# Access Compliance Report

## Public Rights-of-Way

Intersection ID: 17302	Main Street: LINDA_LN	Cross Street: WATER_OAK_RD	Location: NW
ADA ID: 92FD0A0176C6	Ramp Type: Perp	Initial Pass/Fail: Fail	Overall Compliance: No
Severity Score: 46.25			
Codes/Mitigation Info/Possible Solution		Field Measurements/Component Compliance

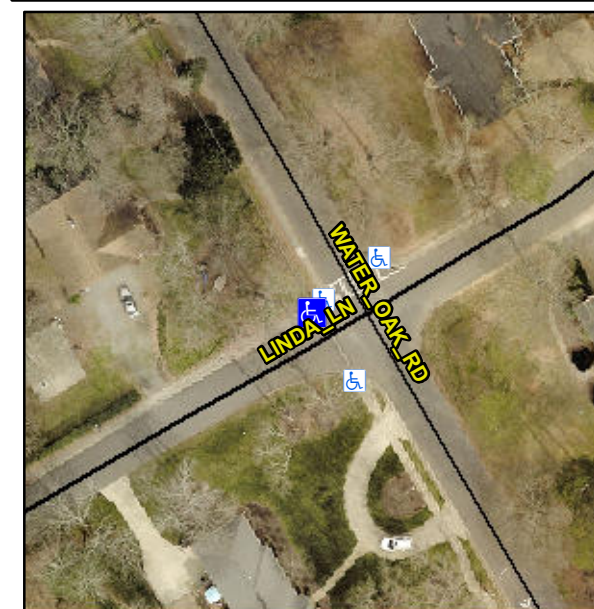
**R304.5.1, R304.2.2, R304.5.3**

Compliance	Description	Data	Compliance	Description	Data
N/A	Ramp Length (in)	49.0	No	Ramp Slope (%)	10.1
No	Ramp Width (in)	47.5	No	Ramp XSlope (%)	14.9
N/A	Flare Type LT	N/A	N/A	Flare Type RT	N/A
N/A	Flare Slope LT (%)	N/A	N/A	Flare Slope RT (%)	N/A
N/A	Flare Traversable LT?	N/A	N/A	Flare Traversable RT?	N/A
N/A	Landing Length (in)	N/A	N/A	DWS Provided?	N/A
N/A	Landing Width (in)	N/A	N/A	DWS Contrast?	N/A
N/A	Landing Slope (%)	N/A	N/A	DWS Length (in)	N/A
N/A	Landing X Slope (%)	N/A	N/A	DWS Full Width?	N/A
N/A	Landing Curb? (Y/N)	N/A	N/A	DWS Offset (in)	N/A
N/A	Shared Landing?	N/A			
N/A	Gutter Ponding?	N/A	N/A	Gutter Slope (%)	N/A
N/A	Gutter Lip Ht (in)	N/A	N/A	Gutter X Slope (%)	N/A
N/A	Painted X Walk1?	No	N/A	Painted X Walk2?	N/A
	X Walk 1 Direction	To S		X Walk 2 Direction	N/A
N/A	X Walk 1 Width (in)	N/A	N/A	X Walk 2 Width (in)	N/A
	X Walk 1 Slope (%)	0.7		X Walk 2 Slope (%)	N/A
	X Walk 1 X Slope (%)	10.6		X Walk 2 X Slope (%)	N/A

**Remove & Replace Entire Ramp.**
